ORIGINATION FORM

Proposed Revisions to a Standard Plans Index
(Please provide all information — Incomplete forms will be returned)

Index Number: 695-001
Sheet Number (s): 1 through 7
Index Title: Traffic Monitoring Sites

Index Number: 695-001
Sheet Number (s): 6-7
Index Title: Traffic Monitoring Site

CABINET LAYOUT DETAILS (Four Lanes or Less)

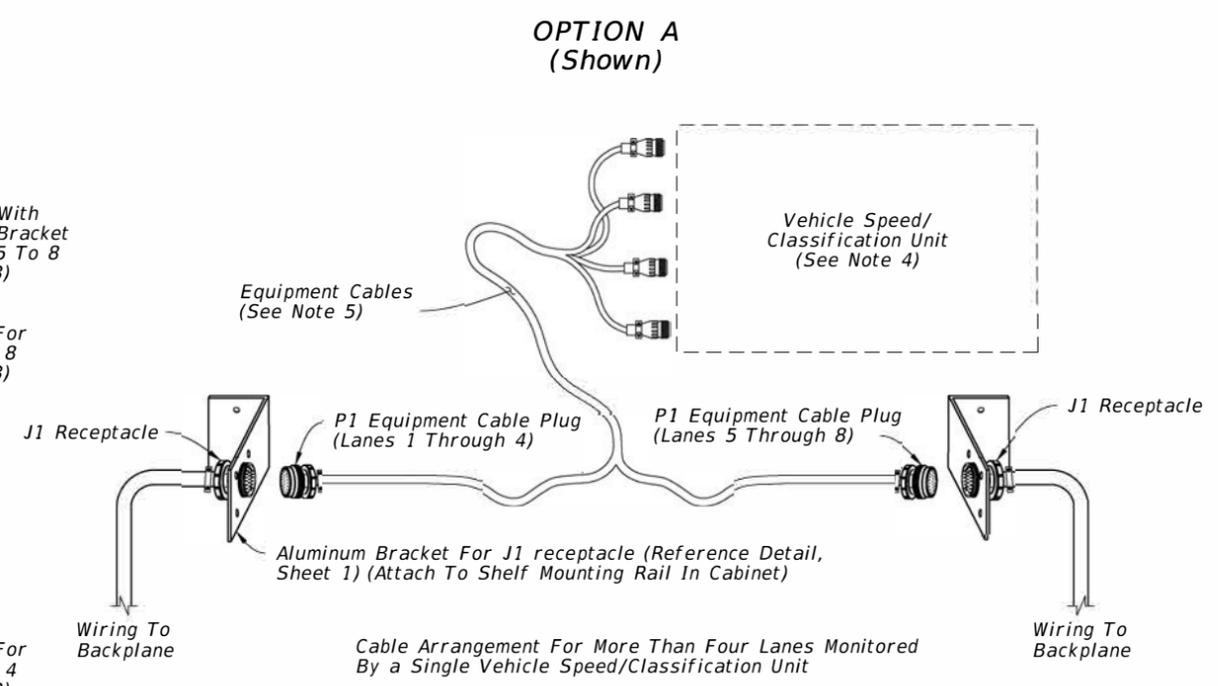
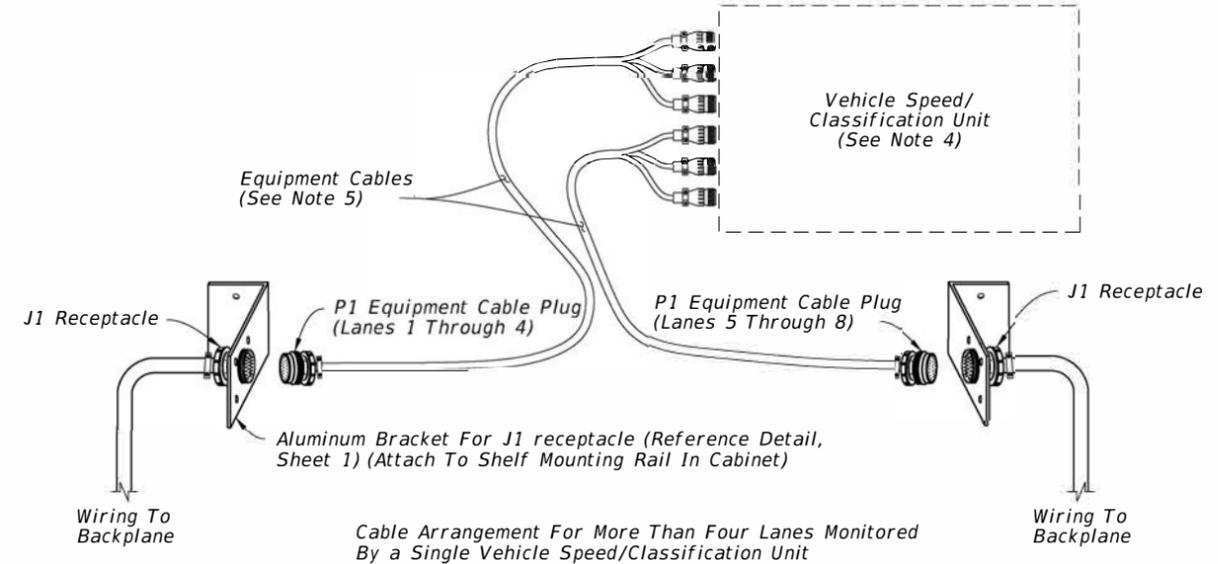
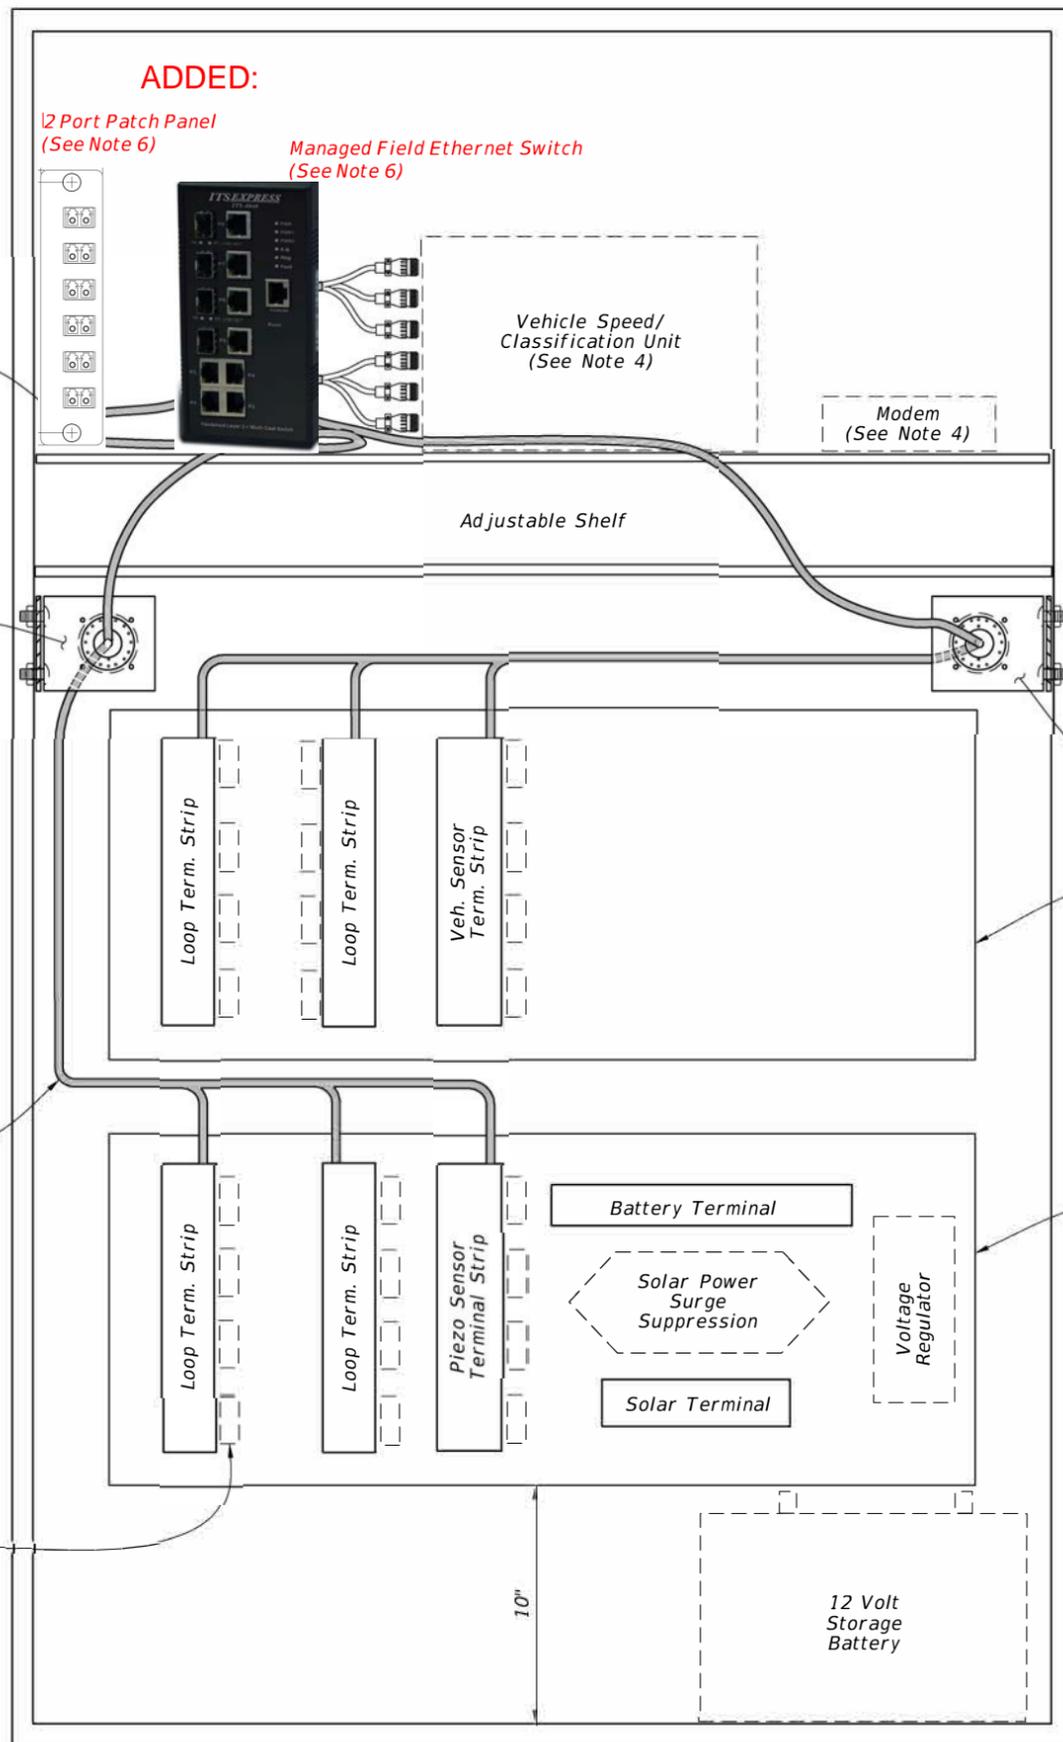
All Sheets: Renumbered
Sheets 1 through 7: Due to introduction of two new sheets, updated the total sheet number from 7 to 9.
Sheets 1, 2, 3, 4: Updated the name of the office from "Transportation Statistics" to "Transportation Data and Analytics".
Sheet 1: Added 12 Port Patch Panel, Managed Field Ethernet Switch, and Note 6 for installation.
Sheet 2: Added 12 Port Patch Panel, Managed Field Ethernet Switch, and Note 6 for installation.
Sheet 4: Change color scheme to vendor provided color scheme
Sheet 6: NEW SHEET describing the telemetered traffic monitoring sites (TTMS) for Type I Lane Configurations A and B.
Sheet 7: NEW SHEET describing the telemetered traffic monitoring sites (TTMS) for Type III Lane Configuration; Added a note to contact the Transportation Data and Analytics office for correct layout based on vehicle classification unit.

CHANGED TO: Data and Analytics

ADDED: Note 6

ADDED: Note 6 — **CABINET LAYOUT DETAILS (Five to Eight Lanes)**

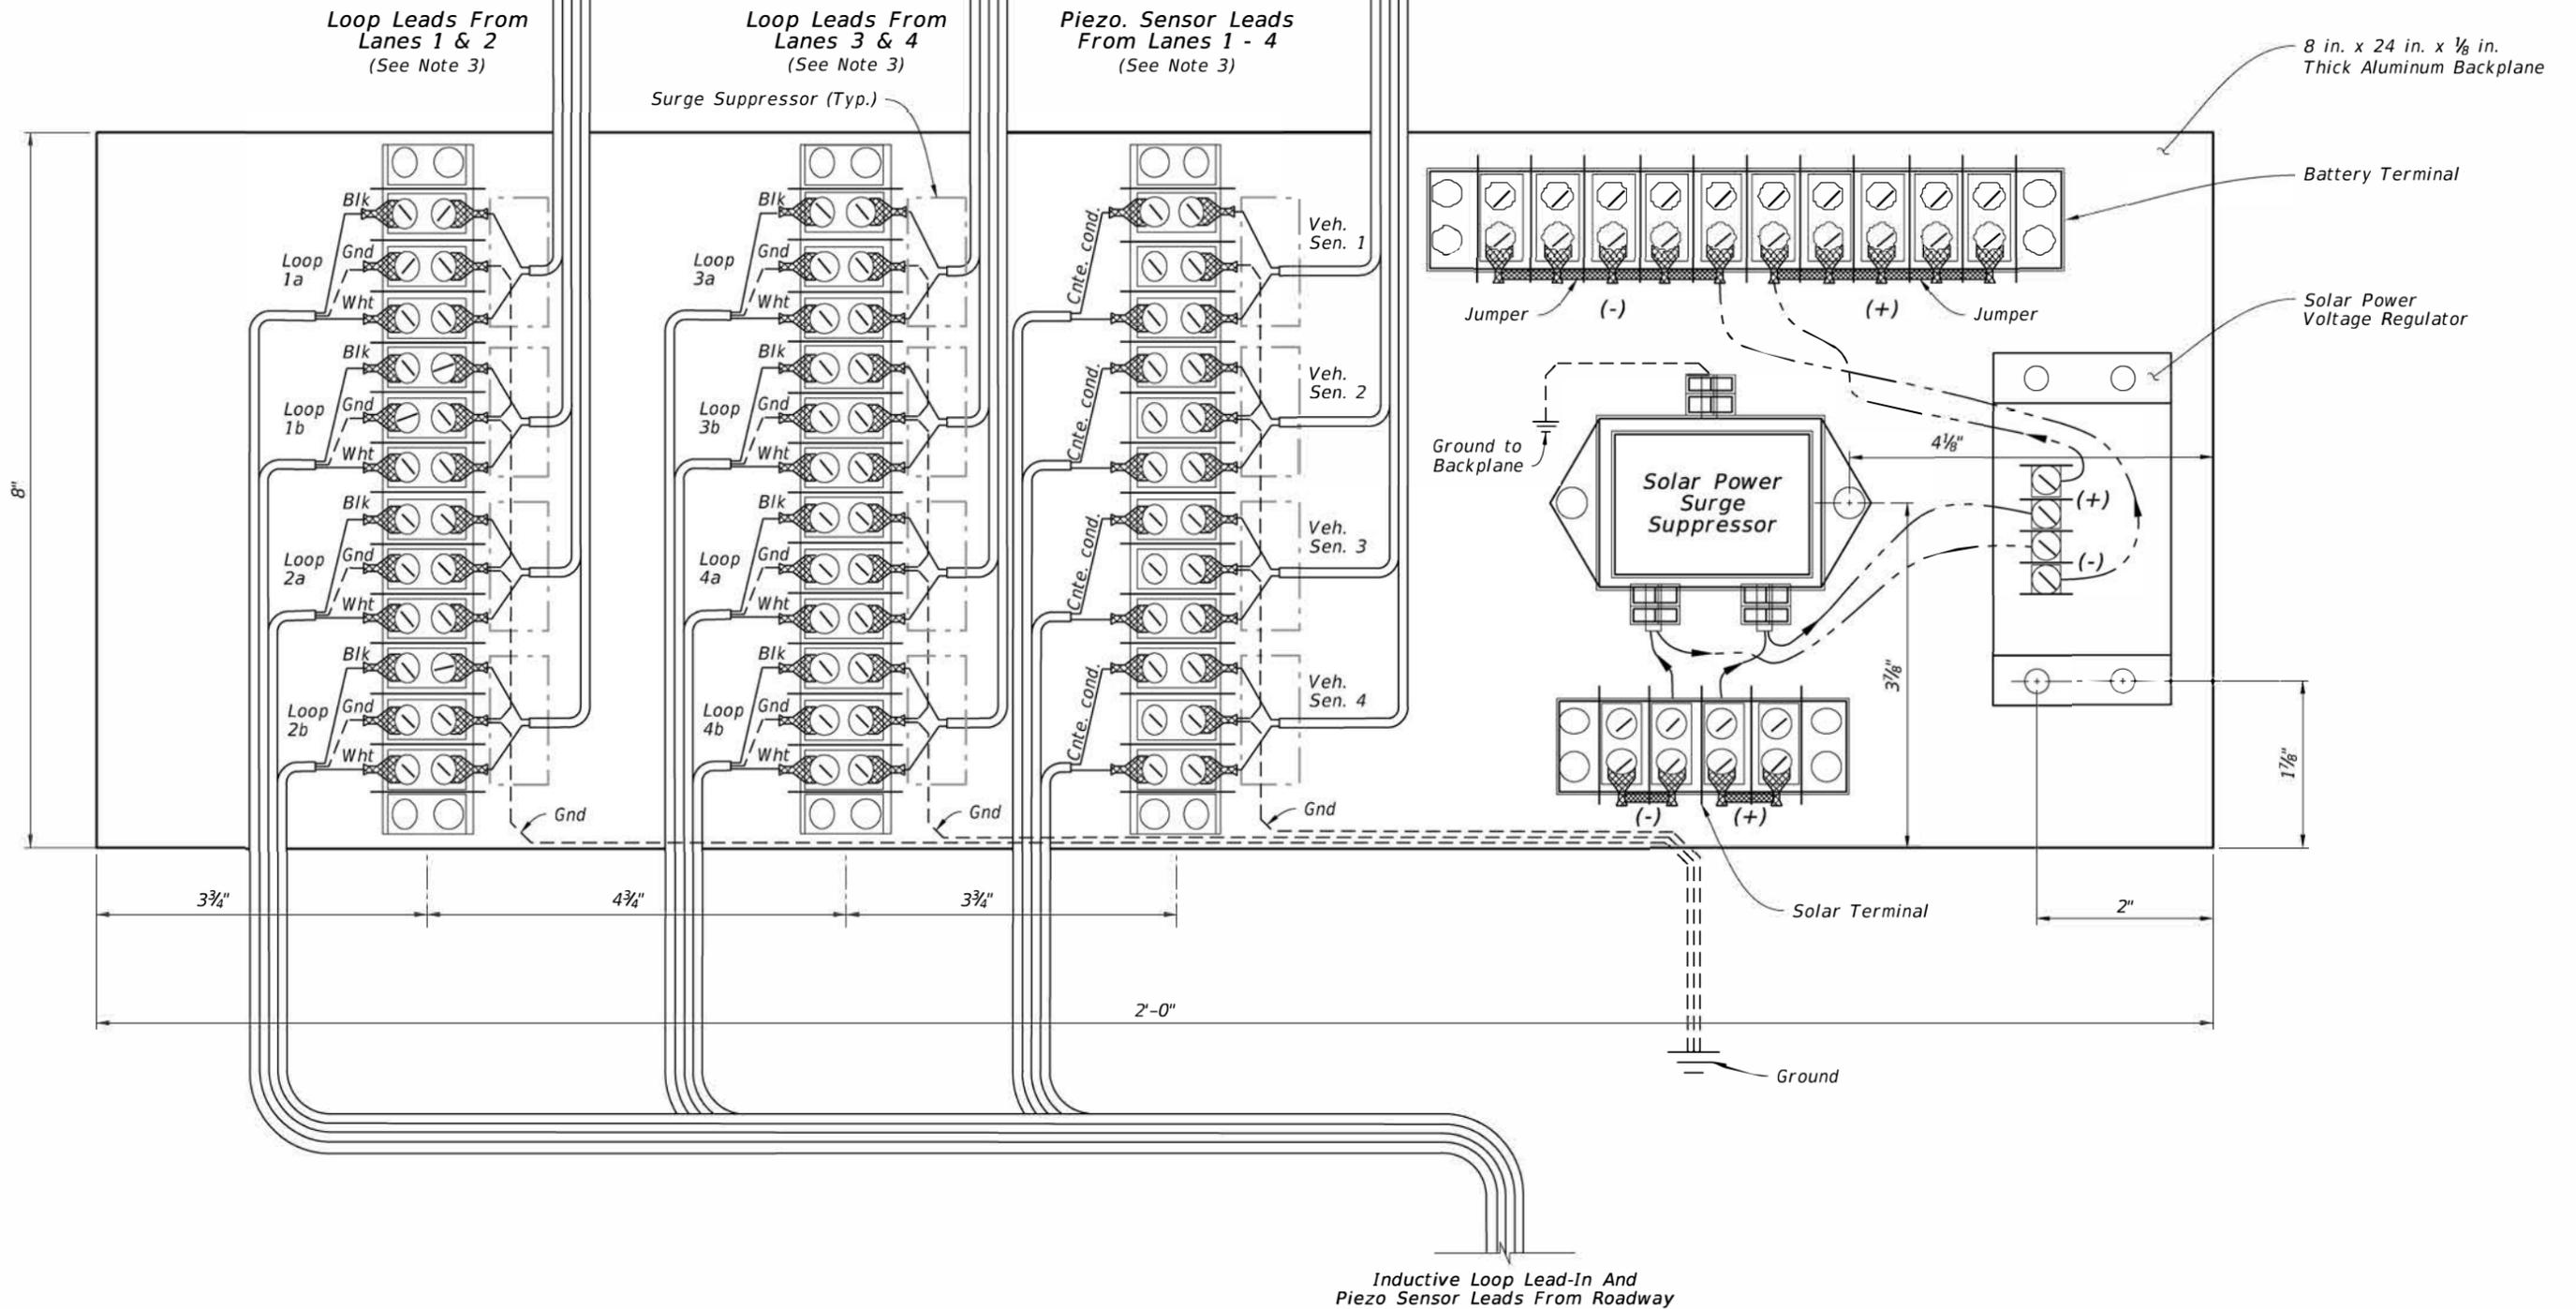
CHANGED TO: Data and Analytics

CABINET BACKPLANE DETAIL

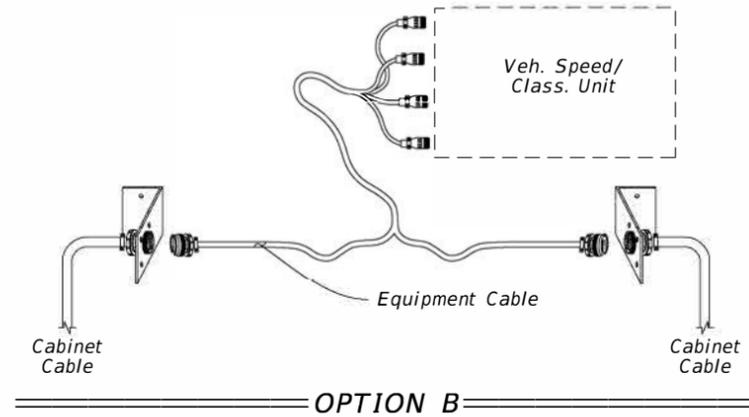
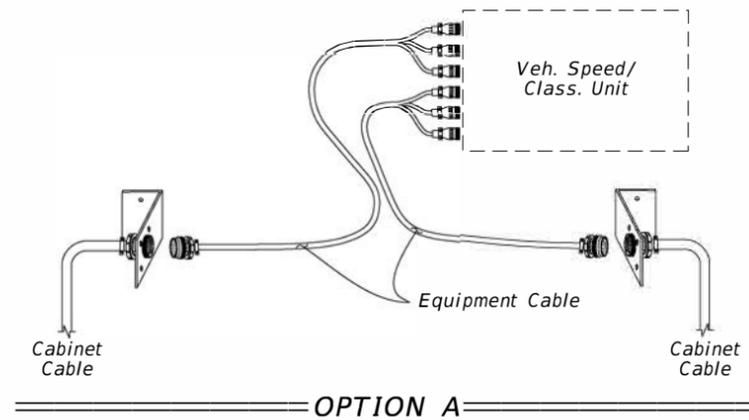
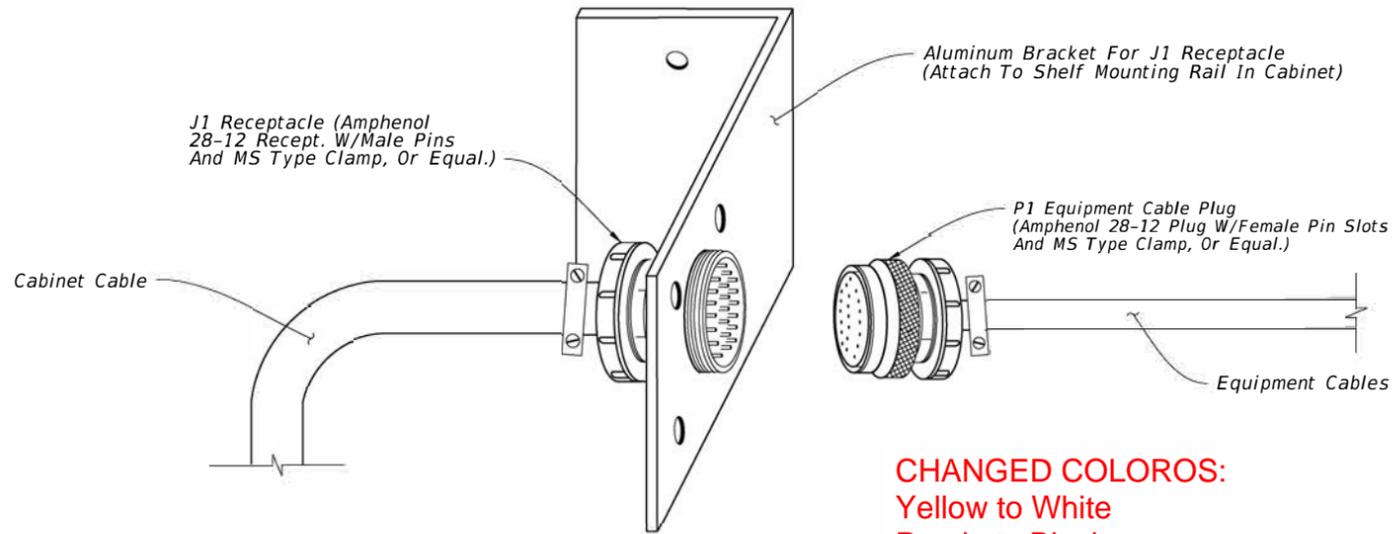
CHANGED TO: Data and Analytics

SHEET
4 of 9

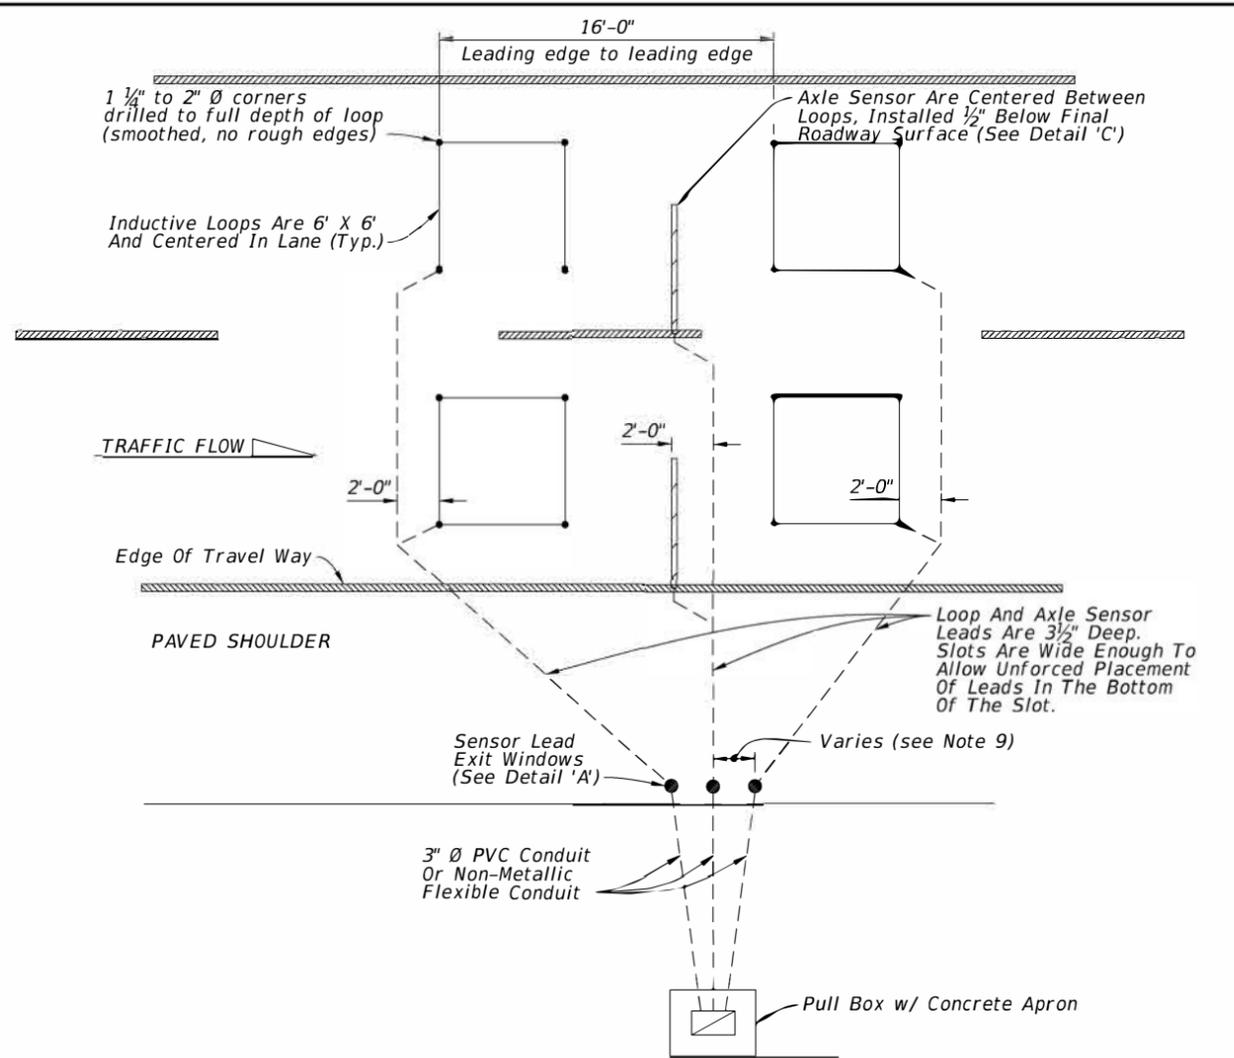
CHANGED COLOROS:
 Yellow to White
 Purple to Black
 Gray to Red
 Pink to Black
 Brown to Green

CHANGED TO: Data and Analytics

CHANGED TO: Green
